Review of ACR Recommendation 3

November 2021

ACR Slate Recommendation 3: Return CAATT Waypoint to Pre-Metroplex location

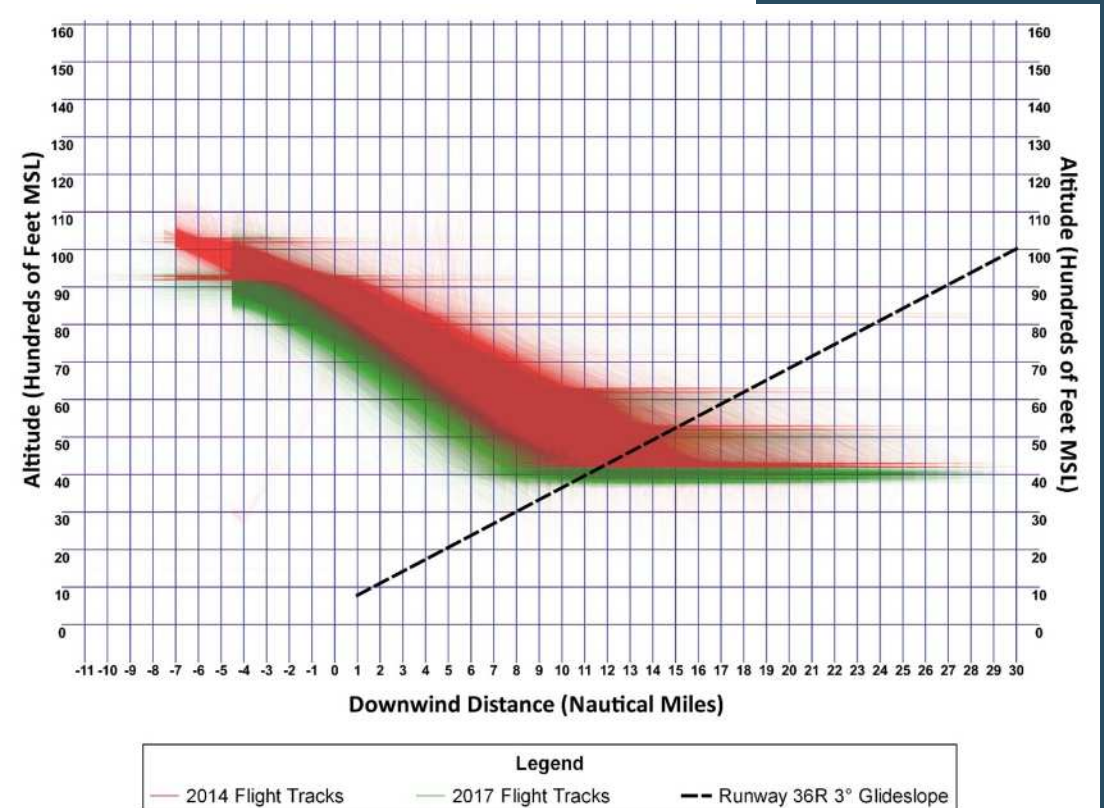
- Bring altitudes on CHSLY arrival closer to pre-Metroplex altitudes
- Under preliminary analysis using the above ACR criteria this recommendation is expected to have a net benefit in noise reduction to over 80,000 residents in the Charlotte Metropolitan area
 - Analysis looked at raising CAATT and EPAYE by 1,000 ft
 - Analysis completed prior to submitting the ACR Slate to FAA

FAA Alternative: Increased Arrival Altitudes at Additional Waypoints

- Modify altitude at CAATT and EPAYE to 10,000 ft and 7,000 ft
 - 1,000 ft higher than current restrictions
 - No increase in flight miles or change to flight tracks
- Requires that the corresponding fixes for other STARs must be raised for operational continuity
 - JONZE STAR: AAIRE and JRDEN raised to 10,000 ft and 7,000 ft
 - FLIPZ and PARQR STARs: CEDOX and VALLL raised to 10,000 ft and 7,000 ft
 - STOCR STAR: LEEKS raised to 10,000 ft; HANDO remains at 8,000 ft
